Notice of Proposed Amendment (NPA)
Regulation- Proposed Changes
CAR-139 Part II
Heliports/Water Aerodrome

Directorate General of Civil Aviation Regulations
Aviation Safety Regulations Department

Ref: NPA-CRD No: 15 -2025 to RMT.2025-15 to CAR-139 PART II

CAR-139 PART II Heliports/Water Aerodrome

Figure 4-5.1. Curved approach and take-off climb surface for all FATOs

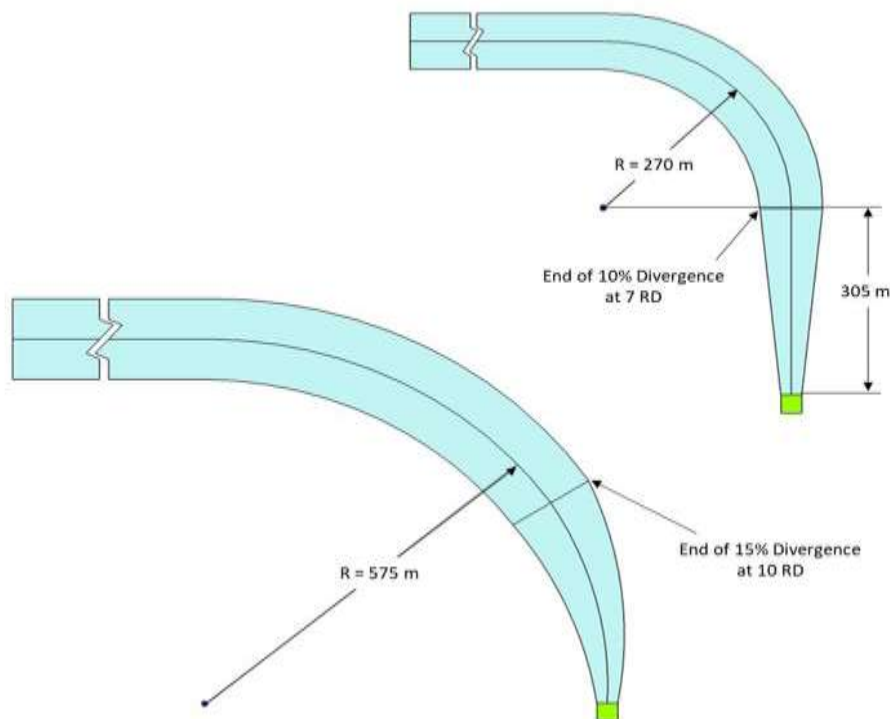
4.1.5 In the case of an approach surface involving a turn or turns, the surface shall be a complex surface containing the horizontal normals to its centre line and the slope of the centre line shall be the same as that for a straight approach surface.

Note: See Figure 4-5 1. For guidance on construction of turns in approach or take-off climb surfaces see the Heliport Manual (Doc 9261).

Editorial Note.— Delete Figures 4-1 to 4-4 and Figure 4-6 and associated notes in toto. Figure 4-5 to be renumbered as Figure 4-1.

Figure 4-2 7. Helideck obstacle-free sector

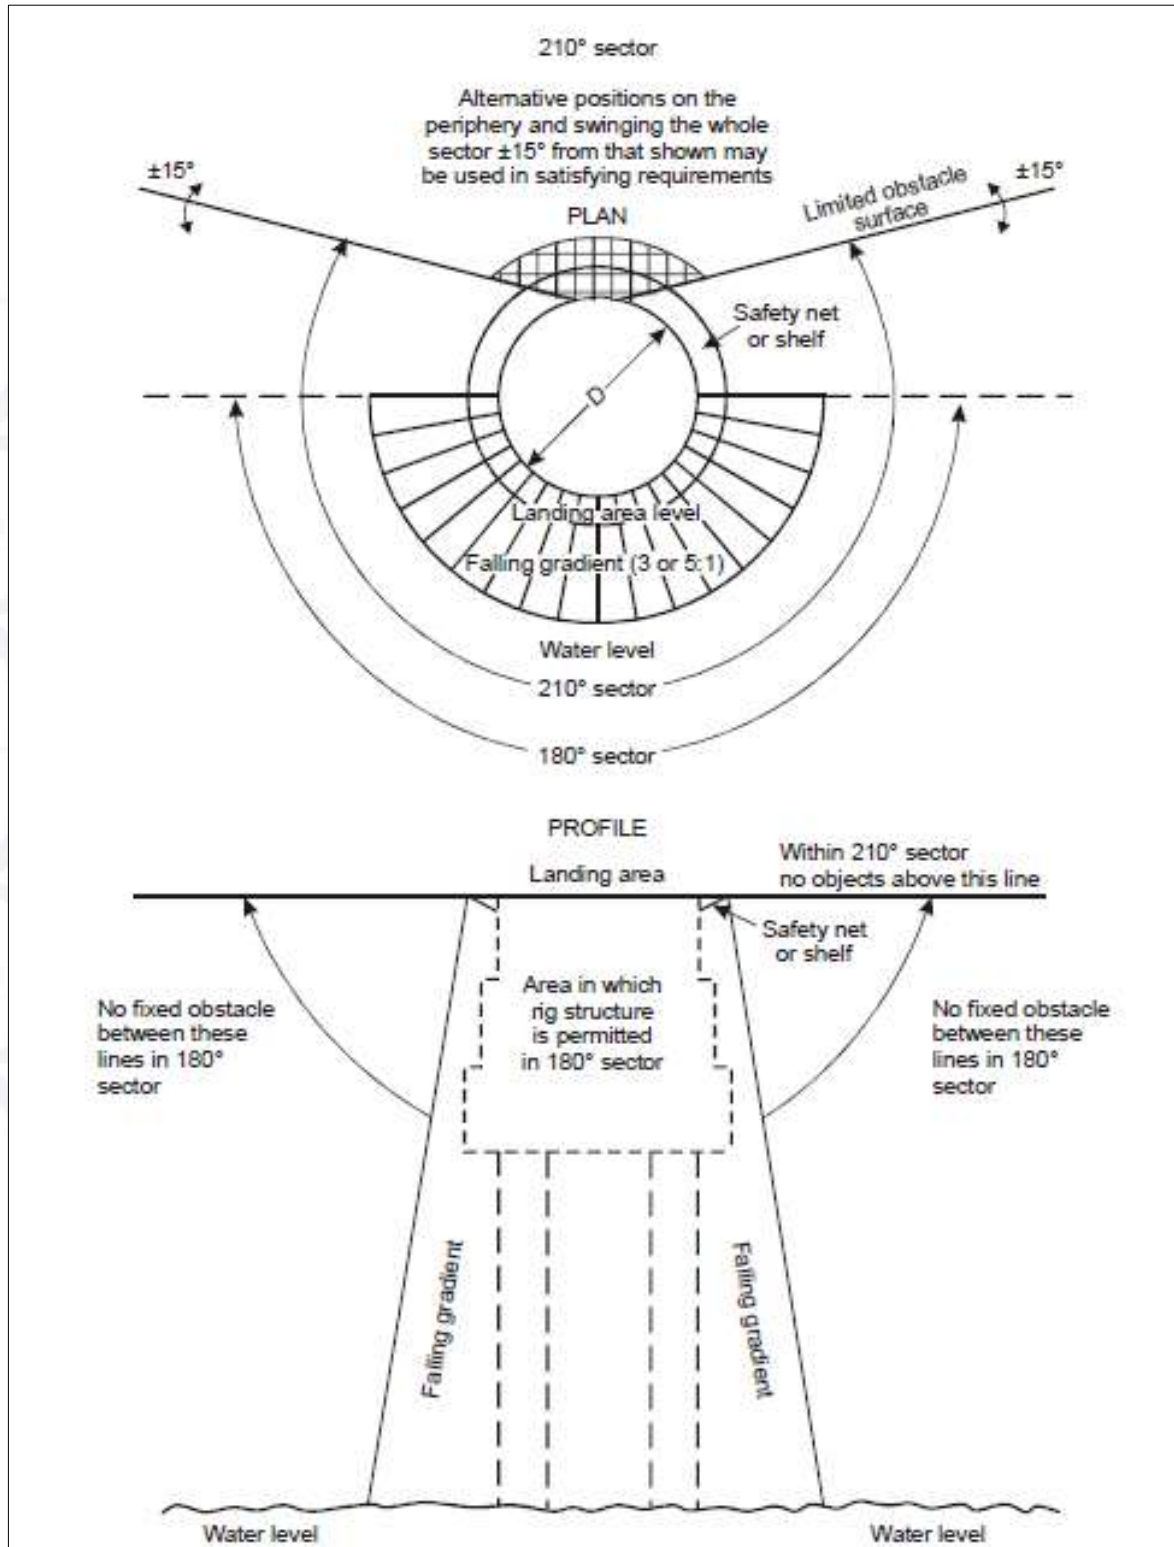
4.1.2124 A helideck obstacle-free sector shall comprise of two components, one above and one below helideck level:

Note: See Figure 4-7 2.

Figure 4-3 8. Helideck obstacle limitation sectors and surfaces for a FATO and coincidental TLOF of 1 D and larger

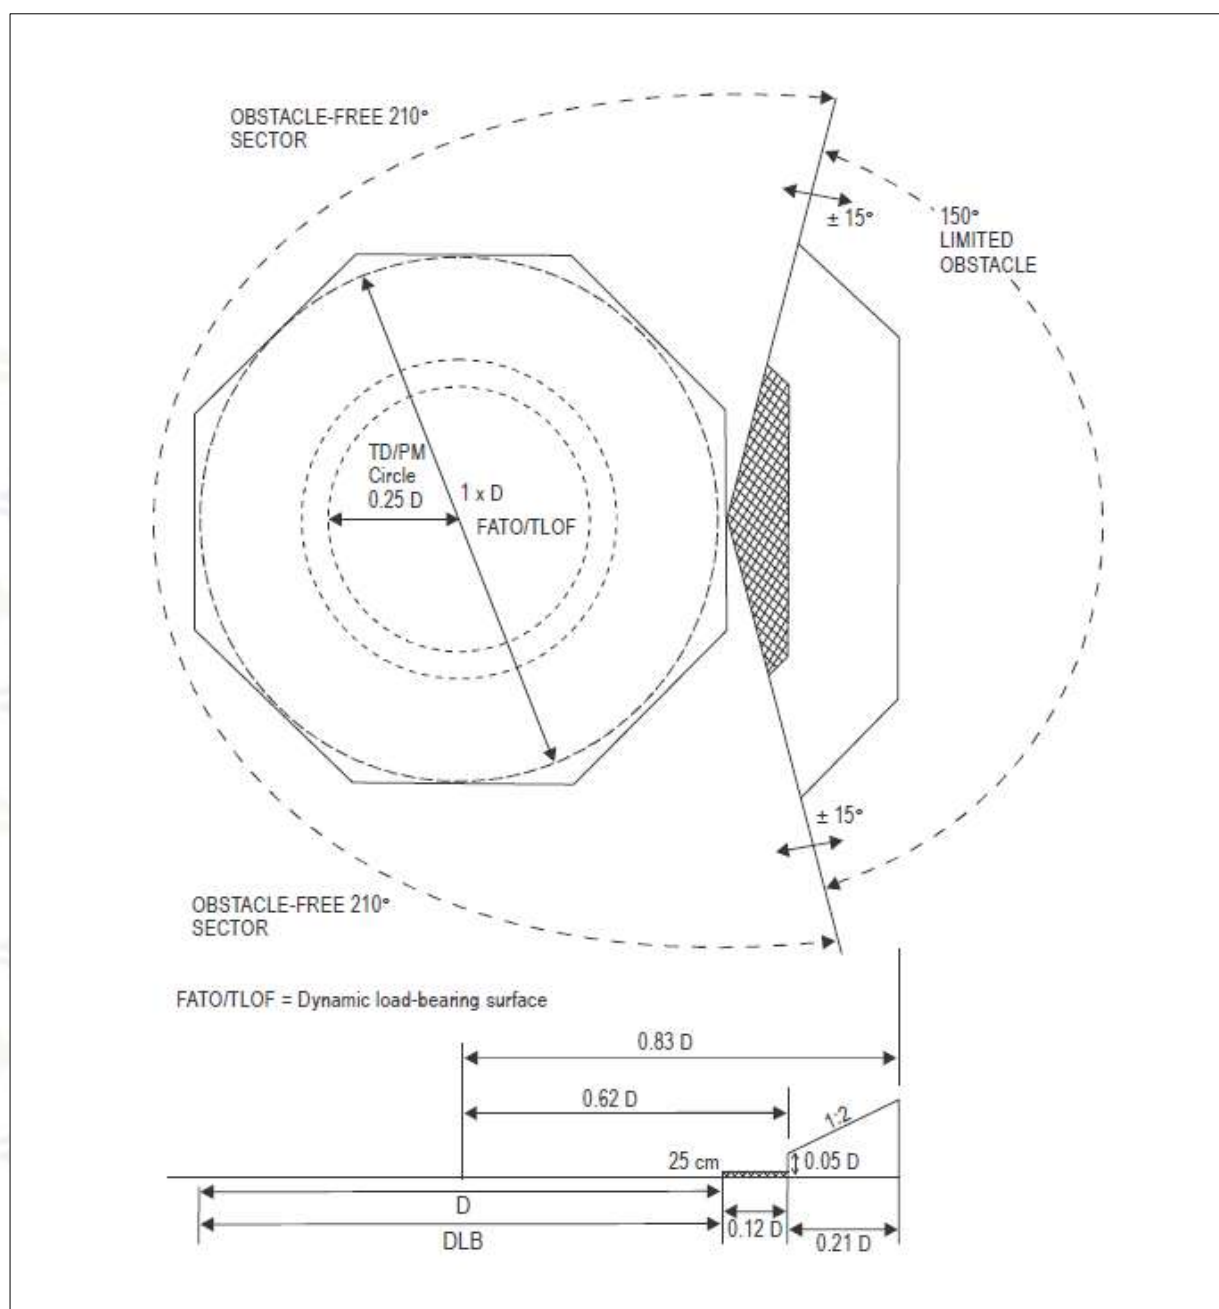
4.2.11 ~~15~~ For a TLOF of 1 D and larger, within the 150-degree limited obstacle surface/sector out to a distance of 0.12 D measured from the point of origin of the limited obstacle sector, objects shall not exceed a height of 25 cm above the TLOF. Beyond that arc, out to an overall distance of a further 0.21 D measured from the end of the first sector, the limited obstacle surface rises at a rate of one unit vertically for each two units horizontally originating at a height 0.05 D above the level of the TLOF. (See Figure 4-3 ~~8~~.)

Note: Where the area enclosed by the TLOF perimeter marking is a shape other than circular, the extent of the LOS segments are represented as lines parallel to the perimeter of the TLOF rather than arcs. Figure 4-3 ~~8~~ has been constructed on the assumption that an octagonal helideck arrangement is provided. Further guidance for square (quadrilateral) and circular FATO and TLOF arrangements is given in the Heliport Manual (Doc 9261).

Figure 4-5 10. Amidship's location — shipboard heliport obstacle limitation surfaces

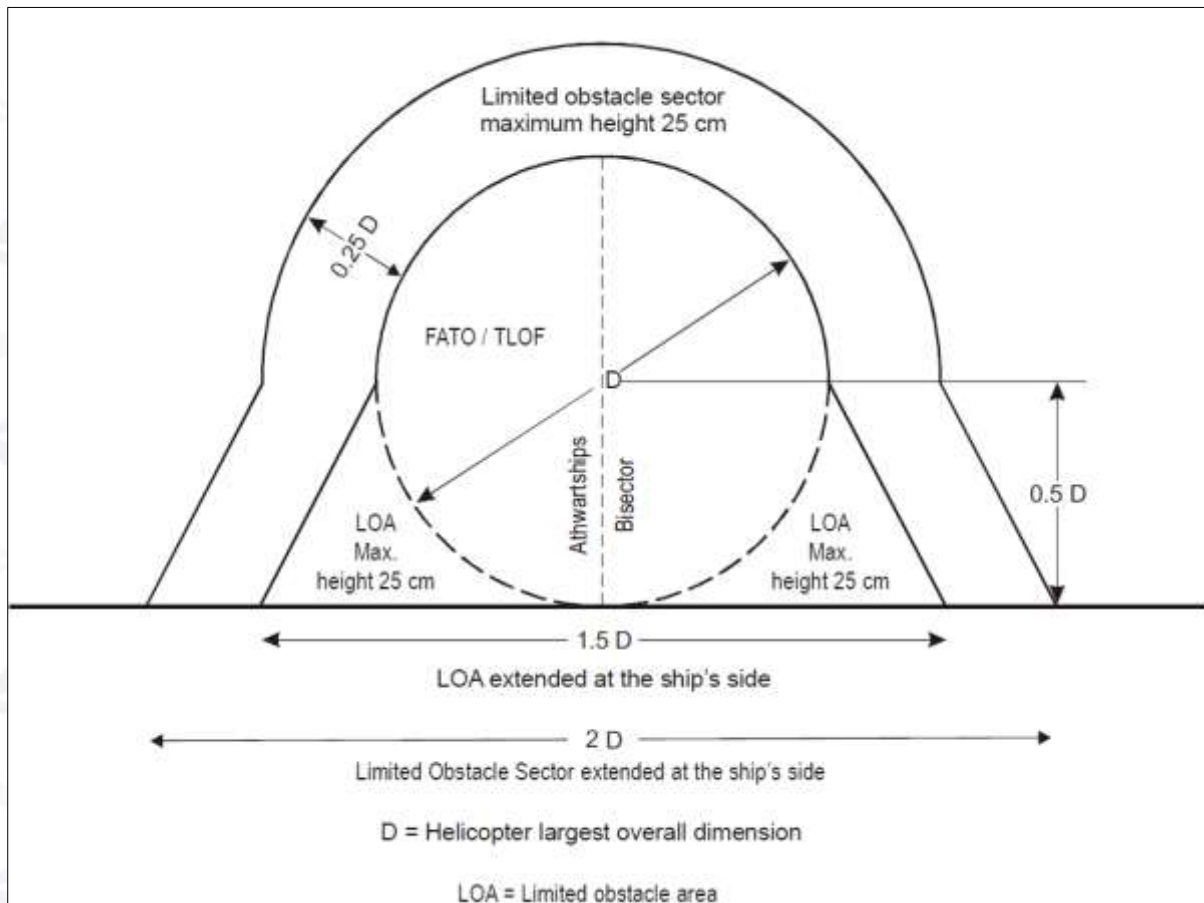
4.2.17 To provide further protection from obstacles fore and aft of the TLOF, rising surfaces with gradients of one unit vertically to five units horizontally shall extend from the entire length of the edges of the two 150-degree sectors. These surfaces shall extend for a horizontal distance equal to at least $1 D$ of the largest helicopter the TLOF is intended to serve and shall not be penetrated by any obstacle. (See Figure 4-5 ~~10~~.)

Figure 4-712. Winching area of a ship

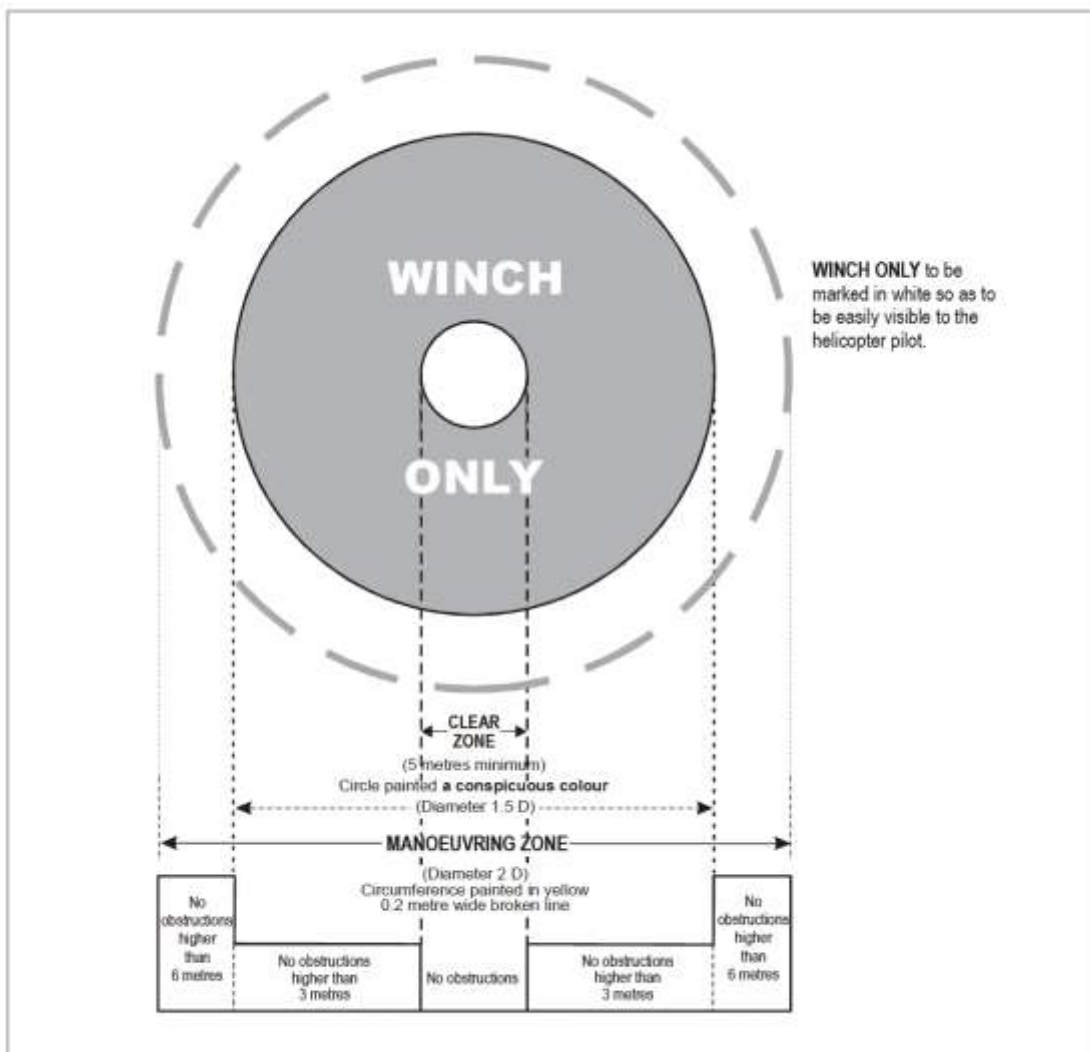
- 4.2.21** An area designated for winching on-board ships shall be comprised of a circular clear zone of diameter 5 m and extending from the perimeter of the clear zone, a concentric manoeuvring zone of diameter 2 D. (See Figure 4-7 42.)
